ORIGINATION FORM

Proposed Revisions to a Standard Plans Index
(Please provide all information — Incomplete forms will be returned)

Index Number: 695-001
Sheet Number (s): 1 through 7
Index Title: Traffic Monitoring Sites

Index Number: 695-001
Sheet Number (s): 6-7
Index Title: Traffic Monitoring Site

LANE CONFIGURATION FOR TMS INDUCTIVE LOOP AND QUARTZ PLEXO AXLE SENSOR

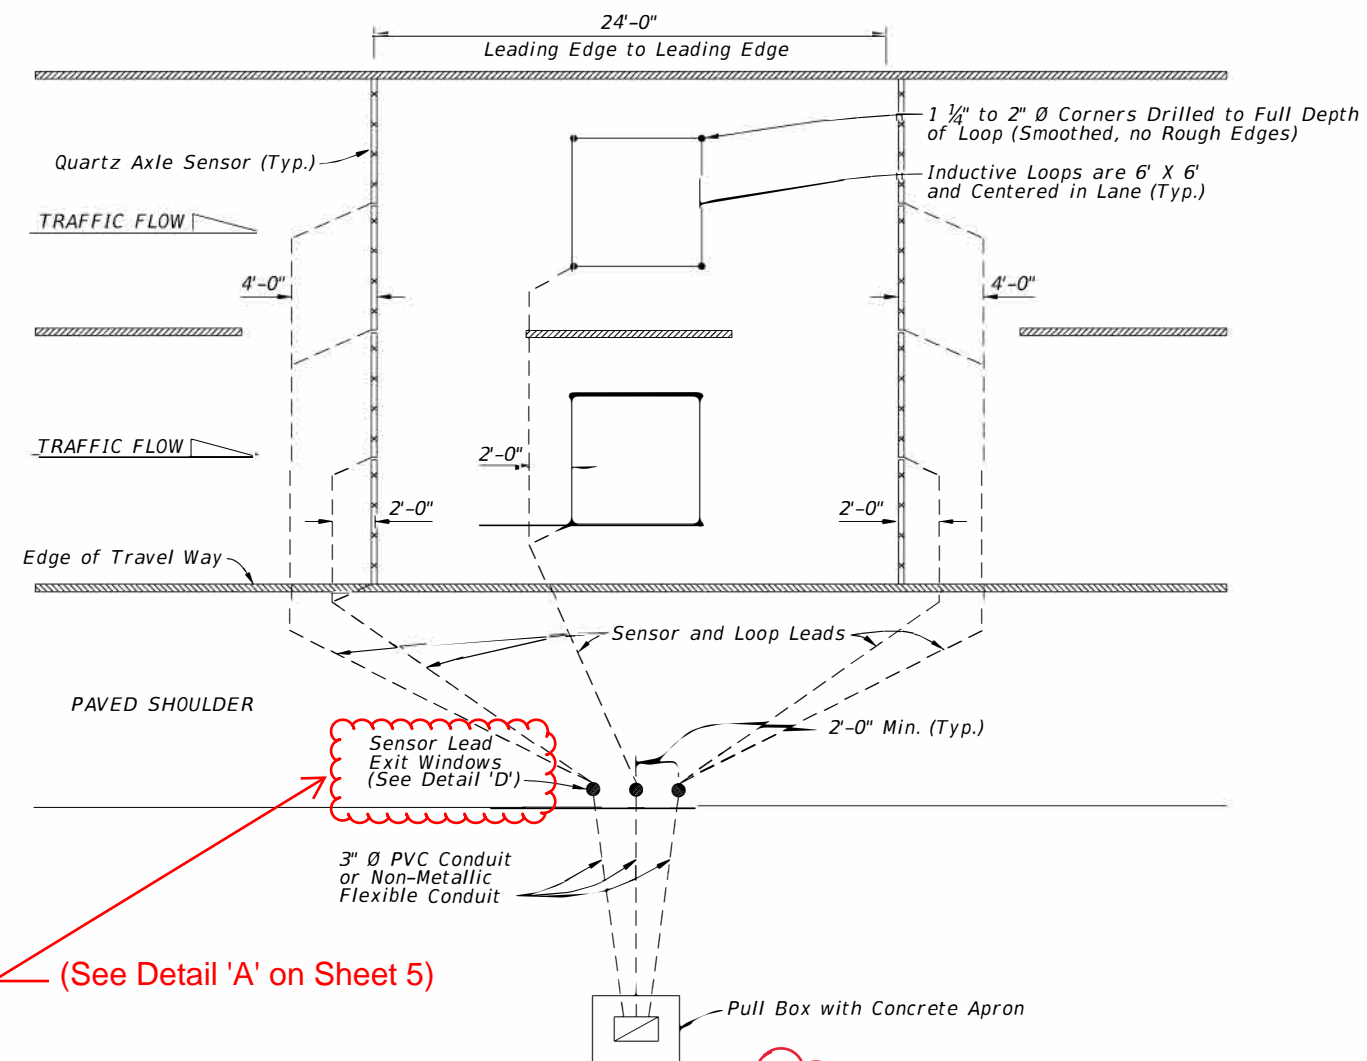
Note: Configuration A and Configuration B are based on the vehicle speed/classification unit. Contact the TMS Manager in the Transportation Data and Analytics Office for correct layout.

NEW SHEET 7

NON-INTRUSIVE VEHICLE SENSOR

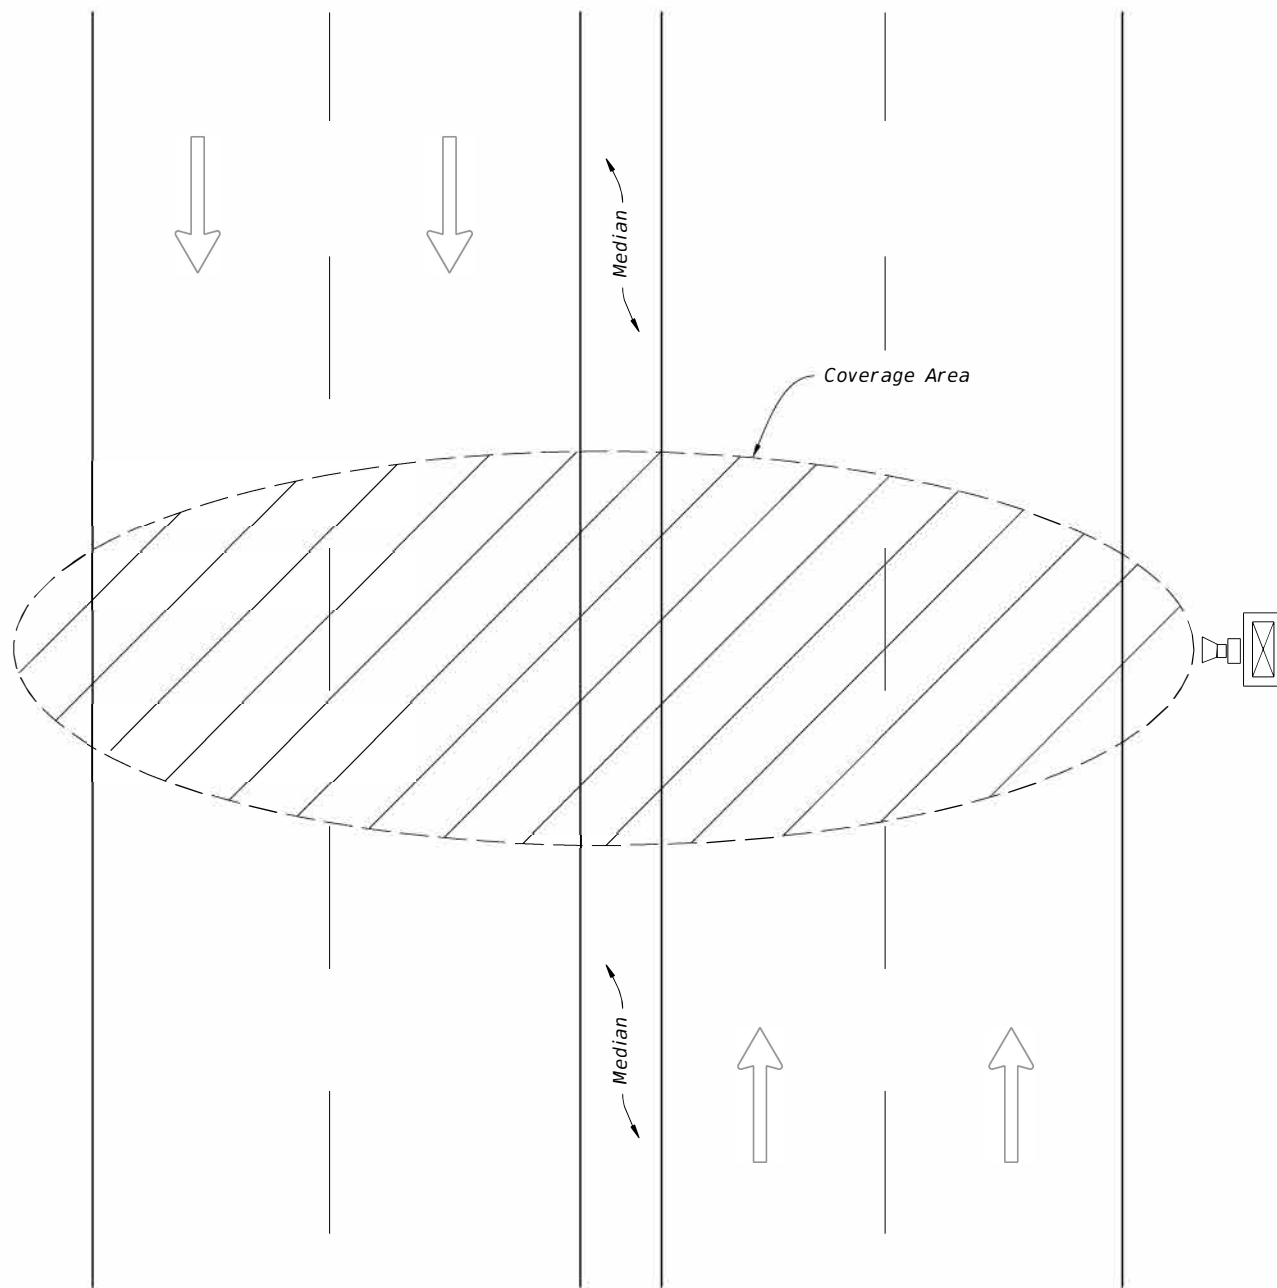
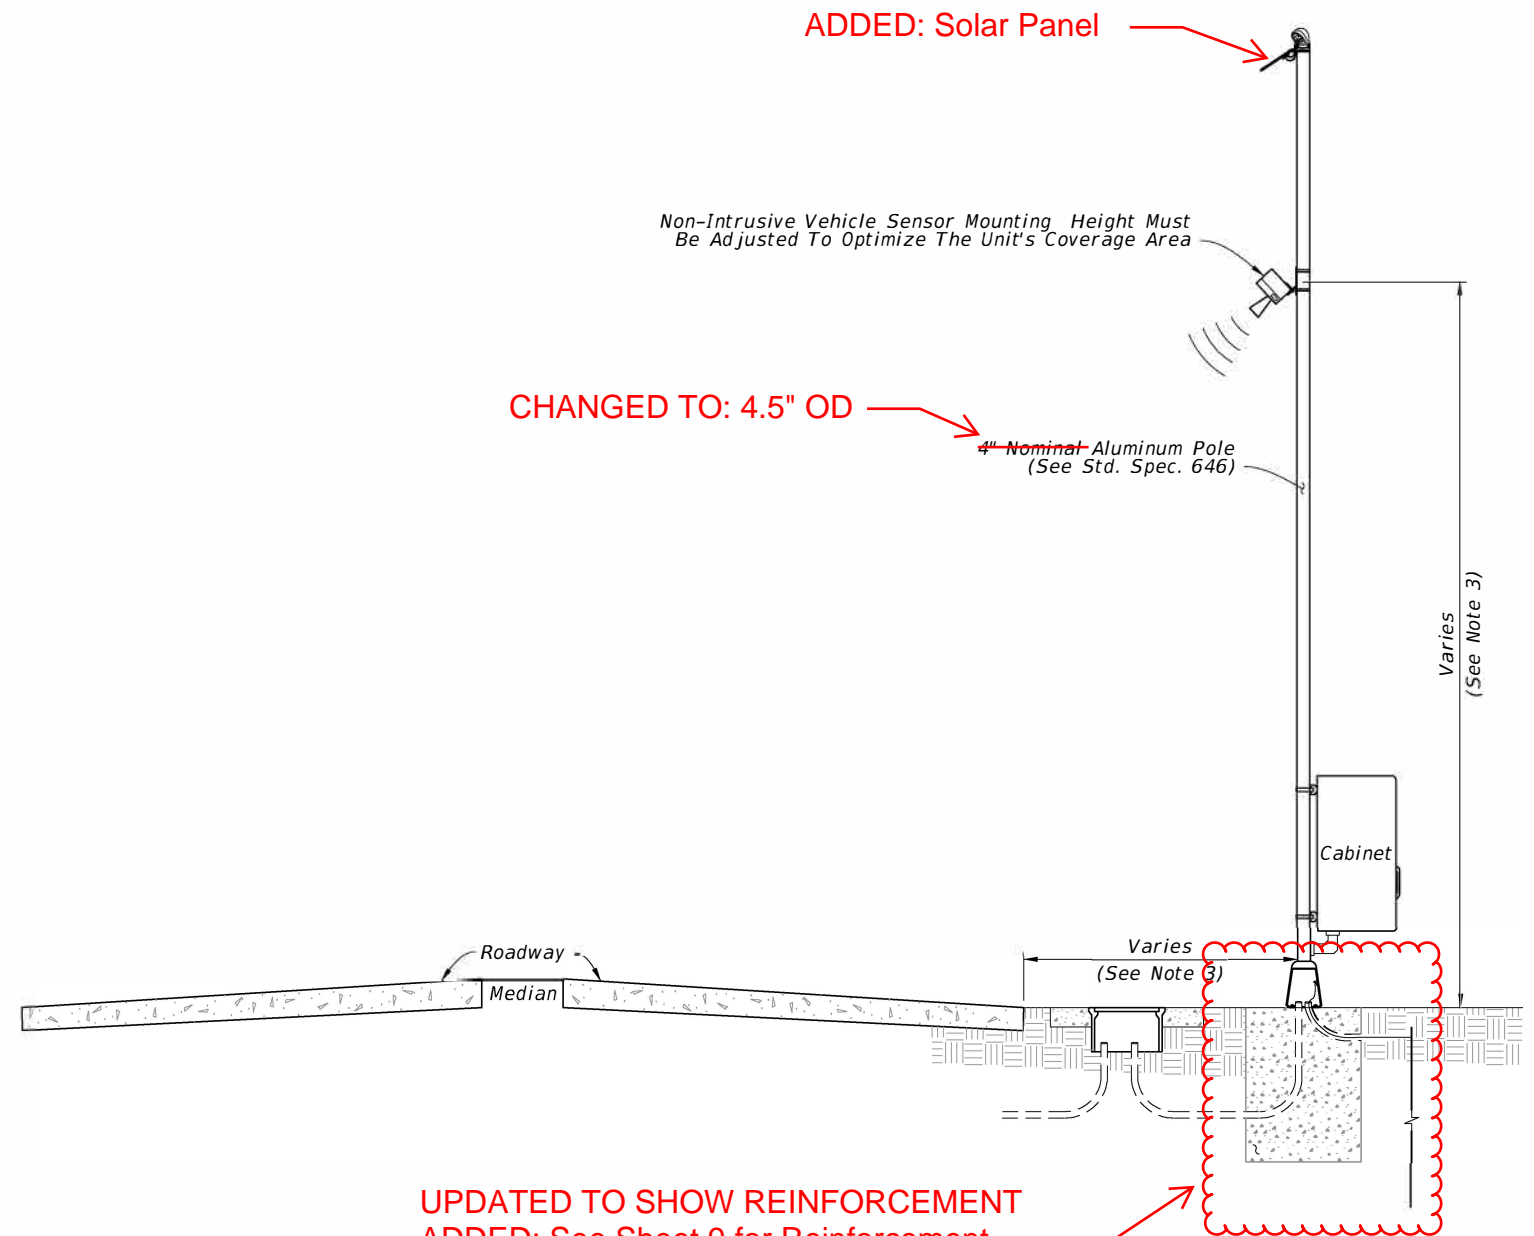
- Sheet 6 (New Sheet 8) - Update Elevation View to match foundation details on Sheet 7 (New Sheet 9); Change "4" Nominal Aluminum Pole" to "4.5" OD Aluminum Pole; Added Solar Panel callout.
- Sheet 7 (New sheet 9) - Update Foundation Details to show bars and stirrups; Update note 2 to reference Spec 646; Update Note 6; Change all references "4" Nominal Aluminum Pole" to "4.5" OD Aluminum Pole.

UPDATED TO SHOW REINFORCEMENT
 ADDED: See Sheet 9 for Reinforcement
 and Grounding Details

SOLAR POWER POLE WITH POLE MOUNTED CABINET (Telemeter Sites)

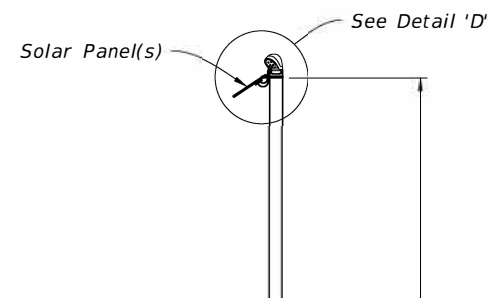
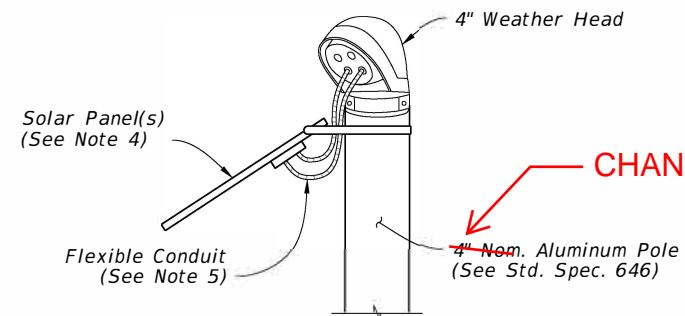
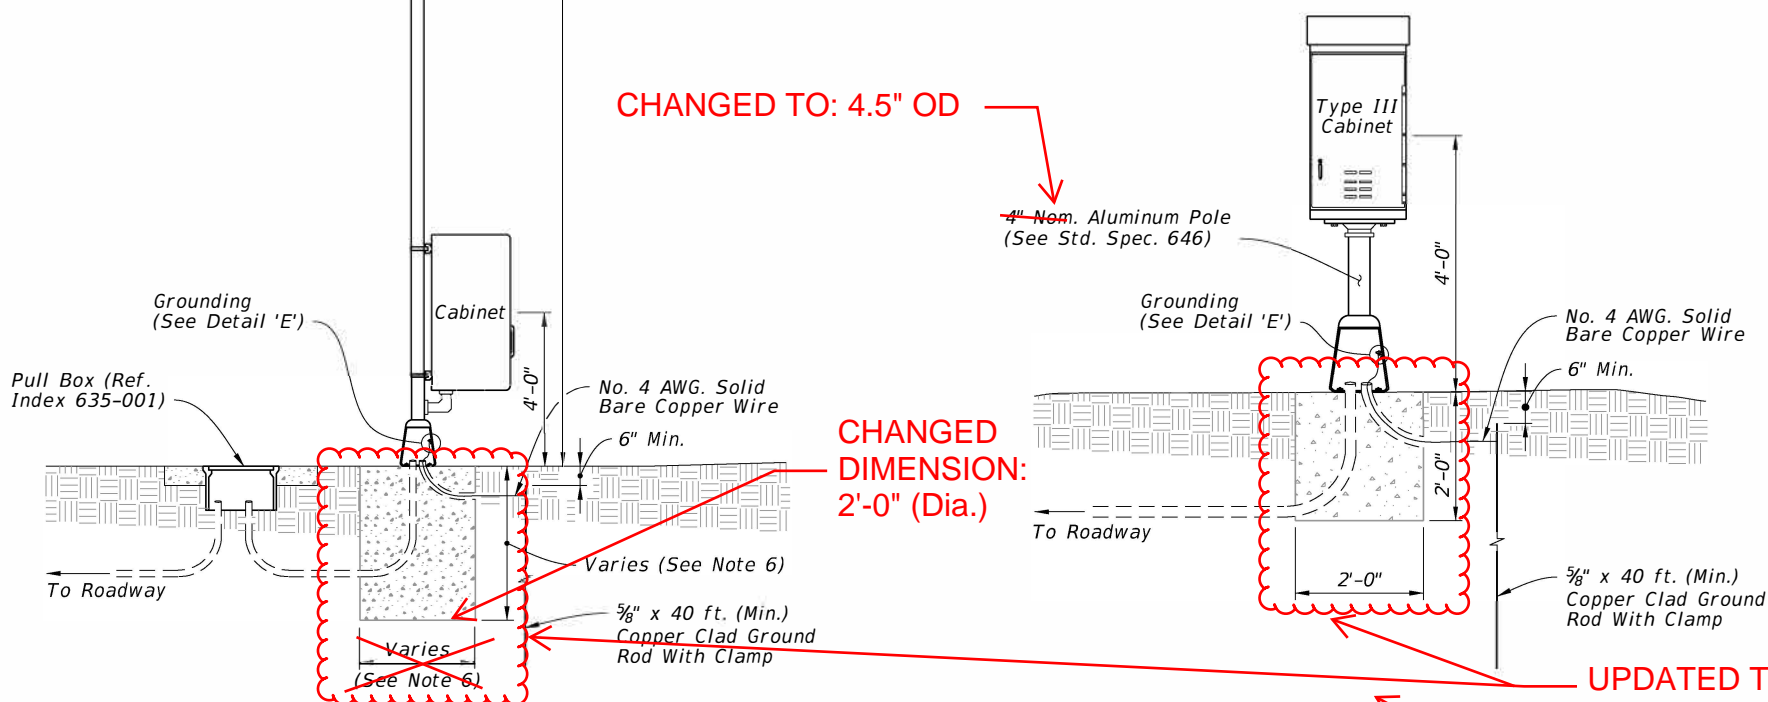
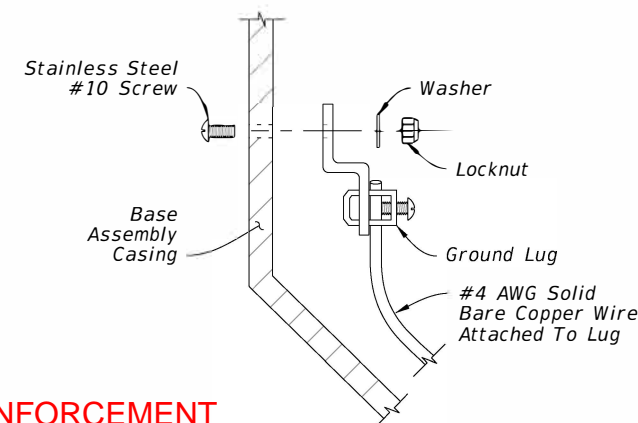
UPDATED NOTE 2: Meet the material requirements of Specification 646.

1. Cabinet installed per Index 676-010 except cabinet center will be 4 feet above grade.
2. ~~Place pole in accordance with the Standard Specification 125.4 and 125.8.2.~~

- b. 12', 15' or 20' poles: ~~3'-0" X 3'-0" wide, a depth of 3'-0"~~
 - c. 30' or 35' poles: ~~3'-0" X 3'-0" wide, a depth of 4'-0"~~
20' or 30'

CHANGED TO: 4.5" OD

~~4" Nom. Aluminum Pole (See Std. Spec. 646)~~

UPDATED NOTE 6b and 6c.

CHANGED TO: Dimensions

CHANGED TO: 4.5" OD

CHANGED DIMENSION: 2'-0" (Dia.)

UPDATED TO SHOW REINFORCEMENT

ADDED: ELEVATION
